MONTGOMERY COUNTY HISTORIC PRESERVATION COMMISSION
STAFF REPORT

Address:	4600 Waverly Avenue, Garrett Park (Garrett-Waverly Neighborhood Park)	Meeting Date:	2/21/2024
Resource:	Garrett Park Historic District	Report Date:	2/14/2024
Applicant:	Town of Garrett Park (Barbara Matthews)	Public Notice:	2/7/2024
Review:	HAWP	Tax Credit:	n/a
Permit Number:	1057416	Staff:	Chris Berger
Proposal:	Sidewalk expansion, retaining wall curb, stairway alterations, and tree removal

Figure 2: This photo provided by the applicant shows the existing sidewalk section to be replaced and widened.

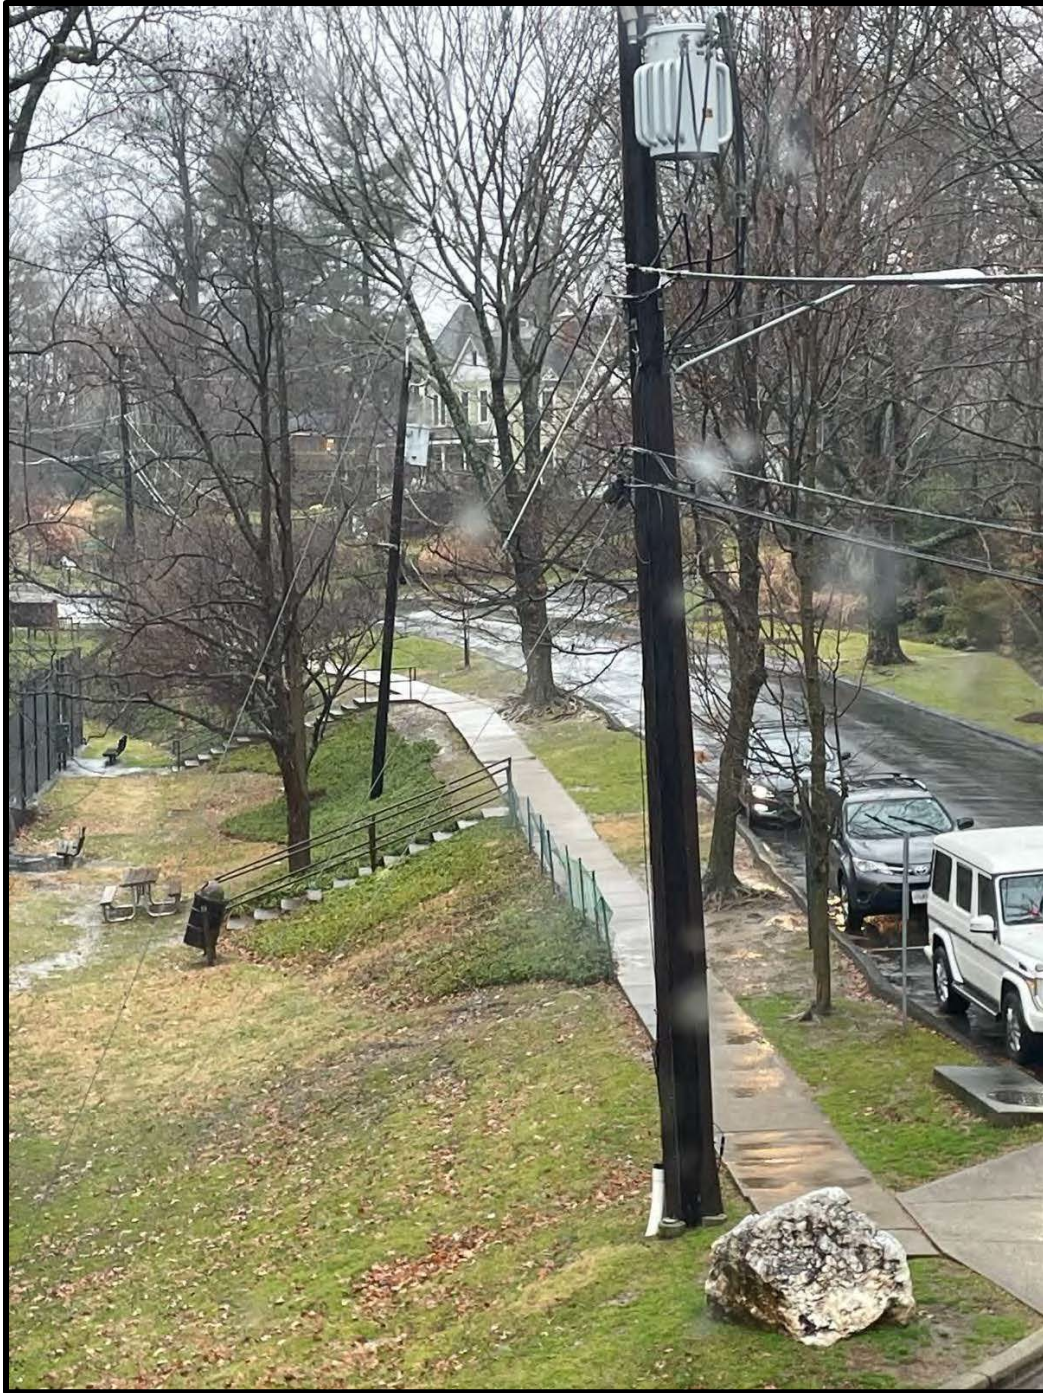
Staff finds the proposed sidewalk replacement and widening meets the applicable regulations and recommends approval. The additional foot of width will have a minimal effect on the environmental setting of the historic district but may be helpful to keep pedestrians on the concrete and not walking on the grass where they could damage tree roots or on the steep grade toward the tennis courts. The replacement sidewalk also is necessary to improve safety and comply with ADA requirements.

Figure 3: This site plan shows both the proposed sidewalk to be replaced and widened and new retaining wall curb outlined in red.

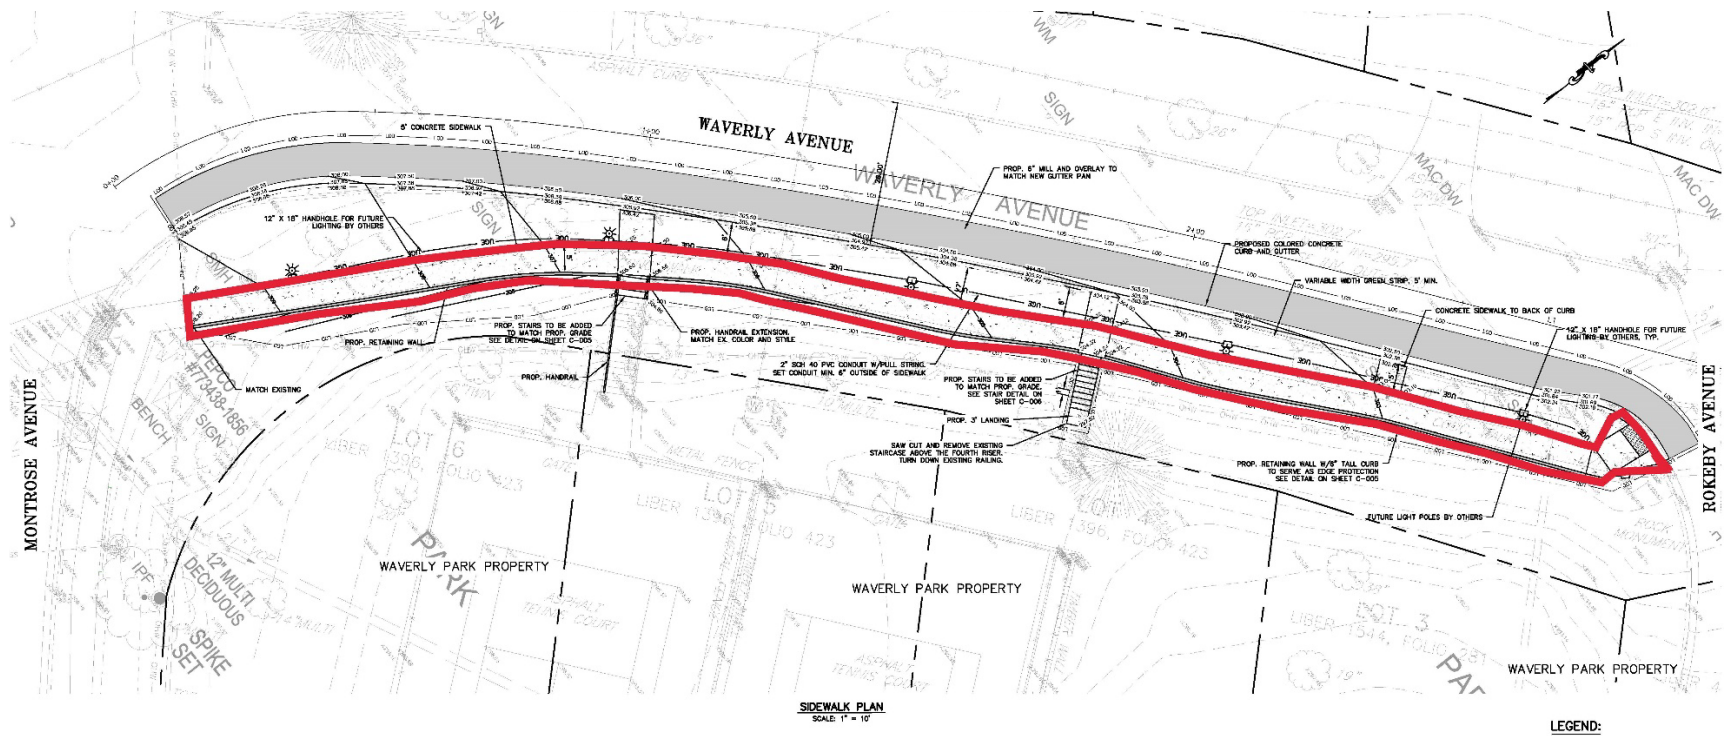
Staff finds installation of the retaining wall curb meets the applicable regulations and recommends approval. It will be built in conjunction with the sidewalk and be located along the south edge of the proposed walk. The retaining curb should help slow erosion and improve safety along the edge of the slope. It may also help keep pedestrians on the sidewalk and off the grass.

Figure 4: This site plan provided by the applicant shows the stairway locations to be altered indicated with red arrows.

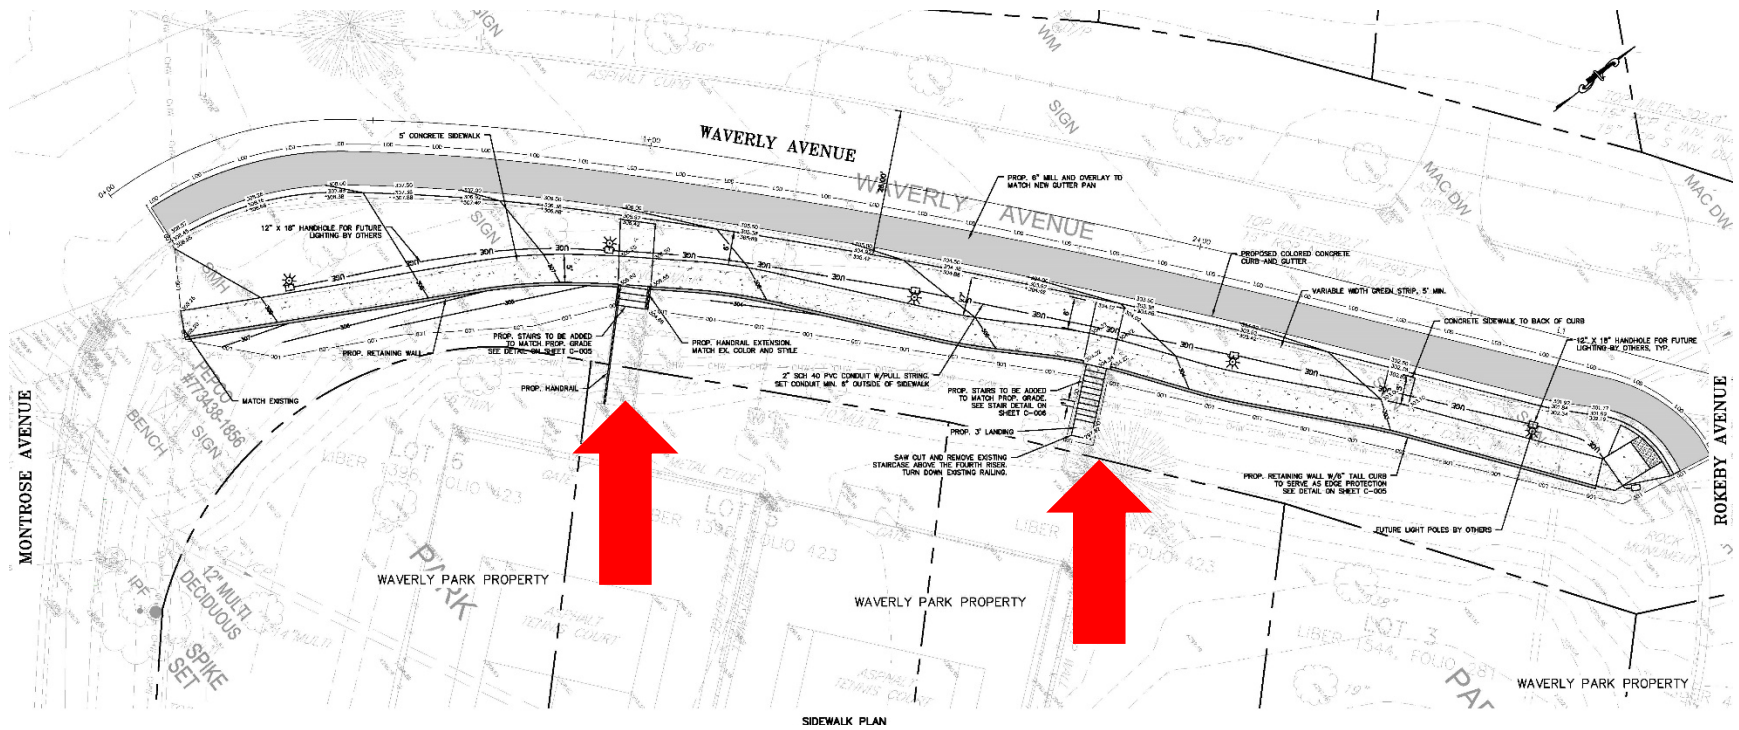
Staff finds the alterations to the stairways meets the applicable regulations and recommends approval. The reconfigured stairs and landings and expanded railings will be necessary to accommodate the wider sidewalk and associated curb.

9 RETAINING WALL CURB NOT TO SCALE

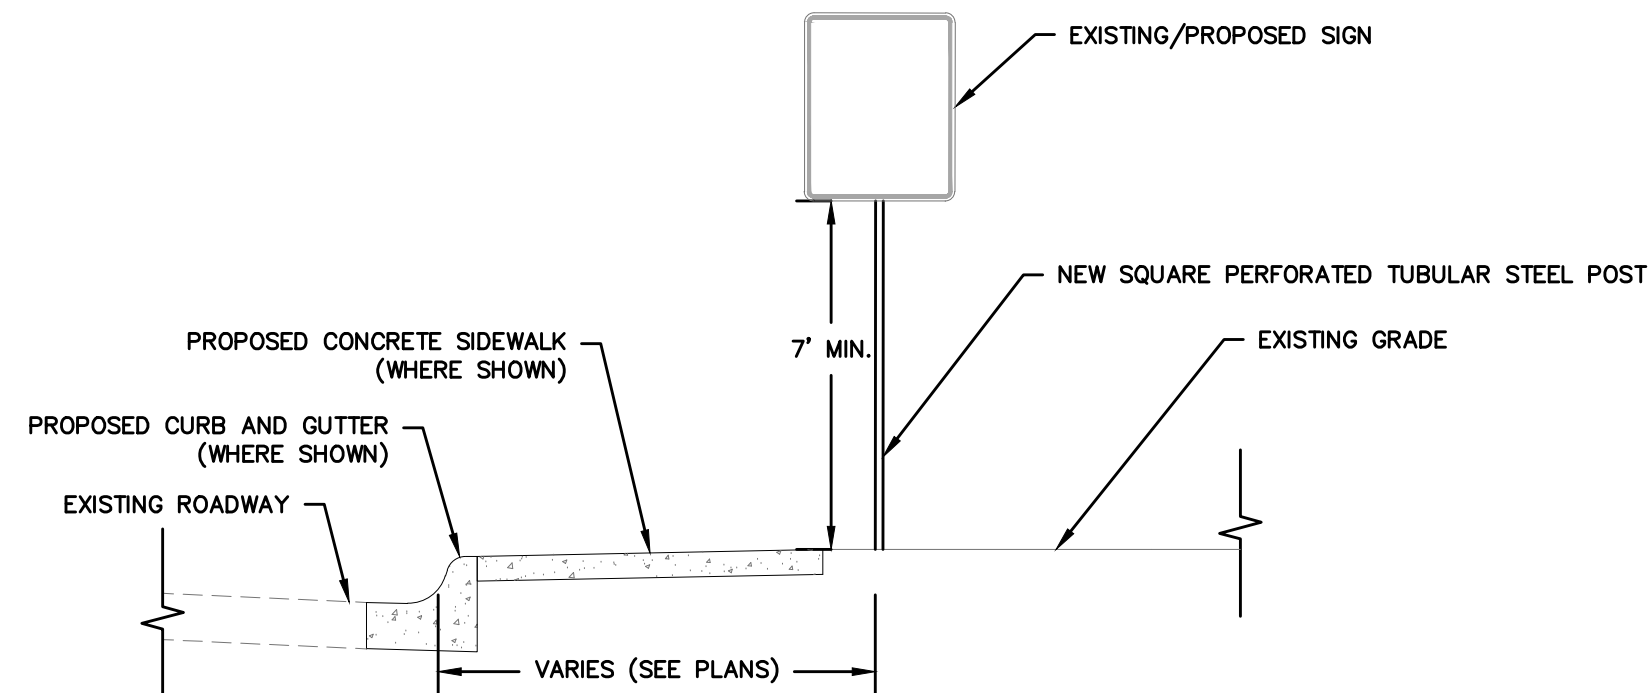
We have received your application to replace and expand the sidewalk along Waverly Avenue. The plan also shows a retaining wall, stairs, and railings close to the sidewalk. Will those be built as part of the sidewalk project? If so please provide details on those proposed features including materials and dimensions. Representative photos may also be helpful.

I apologize for any confusion. There will not be a retaining wall but rather a retaining curb. It is a max of 1.5' tall and monolithic with the sidewalk. Attached is the detail sheet with the retaining curb. Page 2 shows a detail of the stairs.
